Please find below responses to questions as outlined in your respective e-mails regarding the Mine Permit Amendment Application for Mount Polley Mine.

Diane Howe's Comments

M-290
Item 1

Item 1 – Tailings Storage Facility Calculation

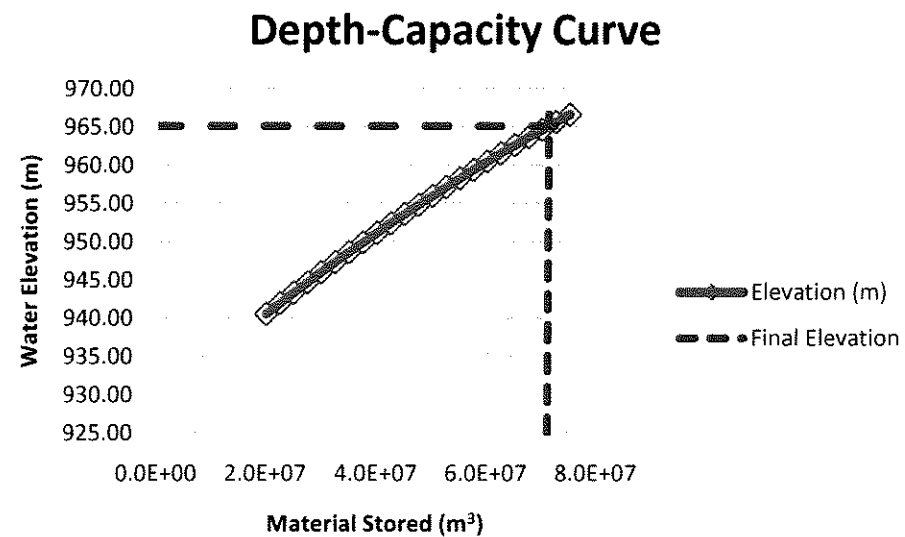
1. Review and supply supporting documentation that projected tailings amount will fit into the TSF (970m).

11. The application indicates that there is sufficient capacity in the permitted TSF to store the additional water from the proposed mine development however page 39 indicates additional dam construction will be required near end of mine life presumably to store additional tailings. There is no report from the design consultant to indicate required dam height or confirm that additional dam construction is feasible.

Based on internal documents including LOM tonnages (32,041,000t of Mill Feed at 2.60 S.G.) and the water balance, in combination with the Tailings Storage Facility (TSF) depth-capacity curve as designed by Knight Piésold, it is projected that all material produced as a result of continuing mining operations, as well as additional items contained within the permit amendment, will be able to be stored within the Dam structure as designed. Final projected elevation of the TSF is 966.51m (freeboard included), with current ultimate design to 970.0m. Full calculations are as included in **Item 1**.

Existing Dam data is as of the end of November and is calculated from the Water Balance (Mount Polley). Projected Values are as per Mount Polley Reserves (Mount Polley) and the Depth-Capacity Curve (Knight Piésold).

Cumulative tailings to date are as per daily mill throughputs, compiled from daily mill and mine operations data. Water contained in the dam is tracked by means of the water balance, which accounts for all surface and sub-surface water flows collected by various ditches and pipelines that report to the TSF. Water elevation is modeled by the depth-capacity curve provided by Knight Piésold as relating to the dam design, and is verified by monthly surveys of the water surface elevation. A storm and freeboard allowance of 1.39m is added to the projected TSF water level.
